# METROPOLITAN GOVERNMENT OF NASHVILLE AND DAVIDSON COUNTY

## STAFF RECOMMENDATION

1421 Calvin Avenue  
March 19, 2014

**Application:** New construction—infill

Graphic Scale  
1" = 30'

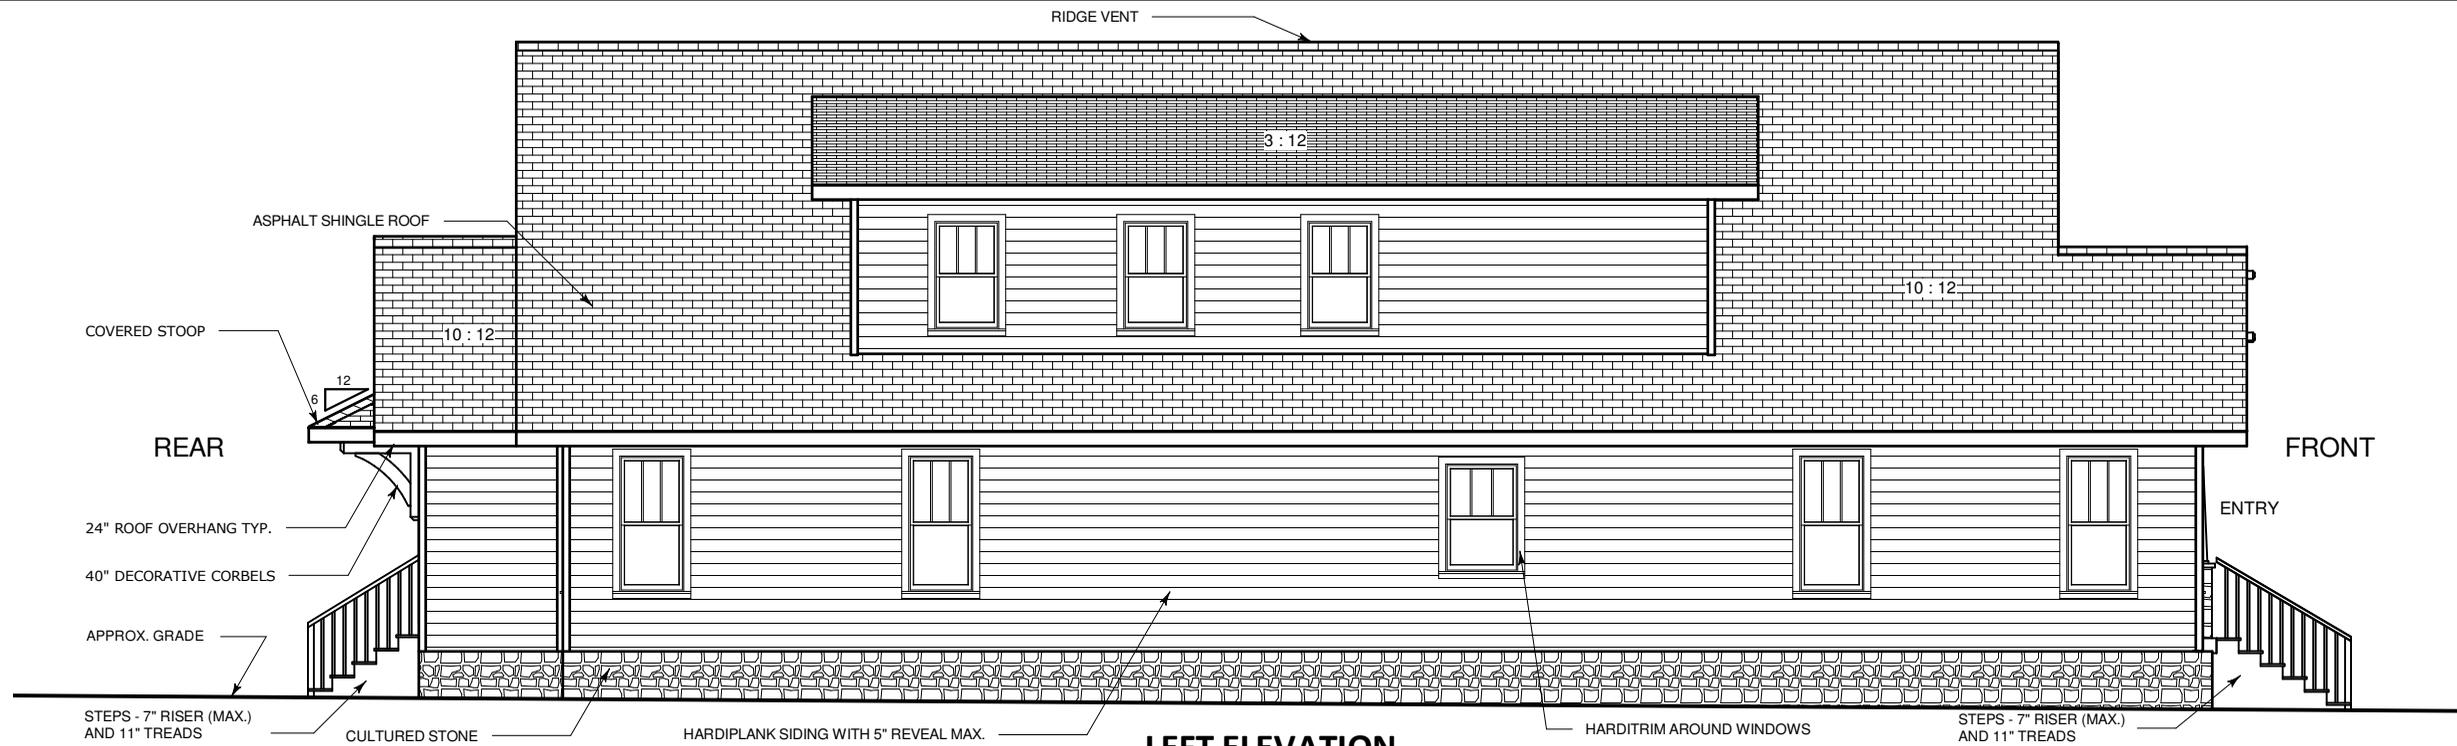
Setback & Rhythm of Spacing: The site plan shows that the house will be thirty-five feet (35') wide. It will be situated slightly off-center on the lot so that it is ten feet (10') from the right/15<sup>th</sup> Street property line and five feet (5') from the left/interior property line, thereby meeting the

base zoning side setbacks. The house's front setback will line up with the front wall of the house next door at 1421 Calvin, which is appropriate. Staff finds that the infill's setback and rhythm of spacing meets Section II.B.3. of the *Lockeland Springs-East End Neighborhood Conservation Zoning Overlay: Handbook and Design Guidelines*.

Orientation: The infill is oriented to face Calvin Avenue, which is appropriate. It has a partial-width front porch that is six feet (6') deep. Staff asks that a central walkway be added from the sidewalk to the front steps. With this condition, staff finds that the infill meets Section II.B.6. of the *Lockeland Springs-East End Neighborhood Conservation Zoning Overlay: Handbook and Design Guidelines*

NO.	DESCRIPTION	BY	DATE
PROJECT DESCRIPTION: <b>Right and Left Elevation</b> <b>Andy Beck - 1421 Calvin</b> 1421 Calvin, Nashville, TN			
DRAWINGS PROVIDED BY: <b>CADWAY</b> <b>Designs</b>			
Date: Mar. 5, 2014			
Scale: As Noted			
SHEET: <b>A-2</b>

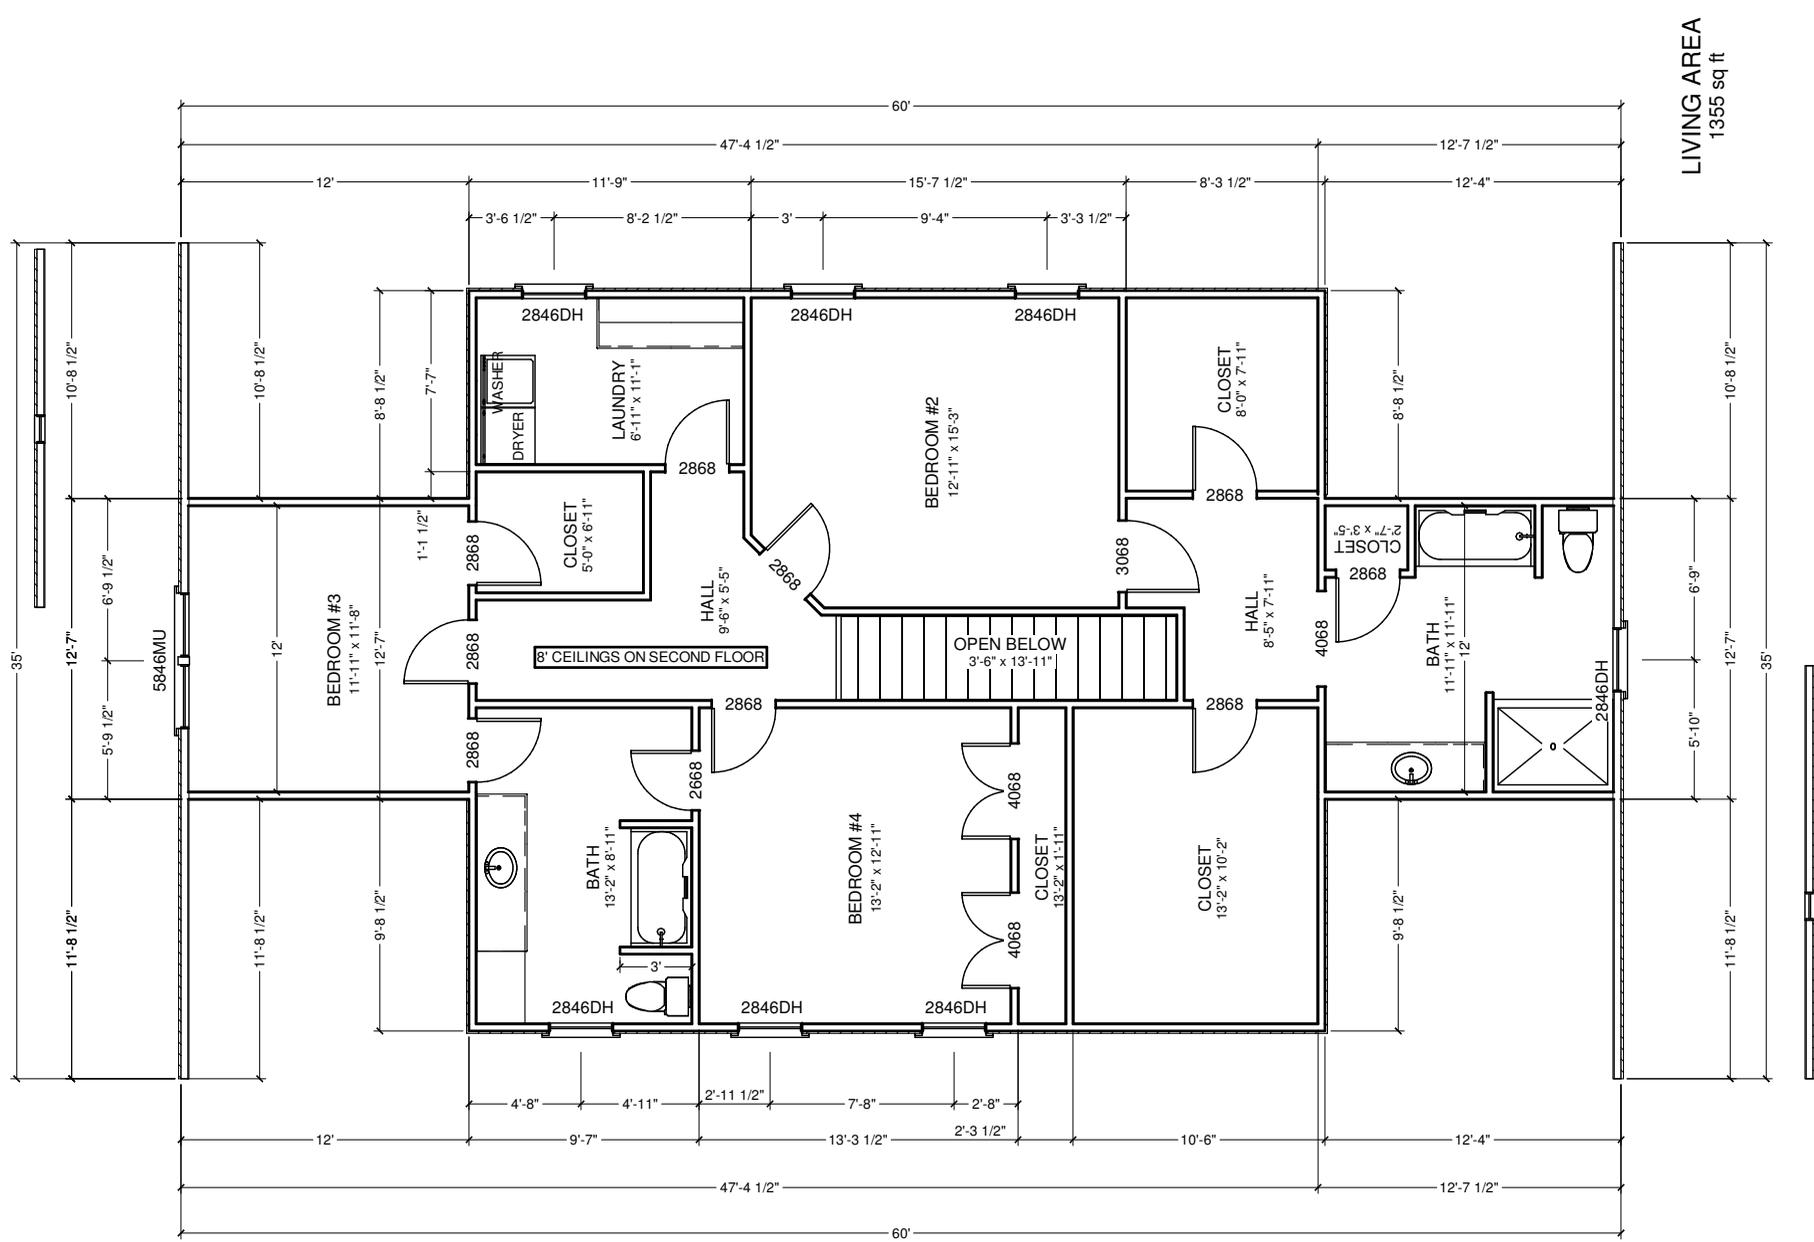
Roof form: The infill has a front facing gable and a gabled bay, both with a slope of 10/12. The infill includes side dormers on both side facades. These dormers are all set two feet (2') below the ridge and two feet (2') behind the wall below. The dormers have shed roofs with a slope of 3/12 and are both thirty-six (36') long. Staff has concerns about the length of the dormer on the right/15<sup>th</sup> Street elevation because it will be highly visible from the side street and historically side dormers were much small in length. Staff asks that a condition of approval be that the dormer on the right/15<sup>th</sup> Street elevation be divided up into two separate dormers. With this condition, staff finds these dormers and the roof form to match the historic context and to meet Section II.B.5. of the *Lockeland Springs-East End Neighborhood Conservation Zoning Overlay: Handbook and Design Guidelines*

1. Staff approve a stone sample, windows and doors, shingle color, and the material of the porch floor prior to purchase and installation of these materials;
2. The long dormer on the right/15<sup>th</sup> Street elevation be divided up into two separate dormers;
3. The front porch columns have a more substantial cap;
4. A central walkway be added leading from the sidewalk on Calvin Avenue to the front porch; and
5. The HVAC be located on the rear façade, or on a side façade beyond the midpoint of the house.
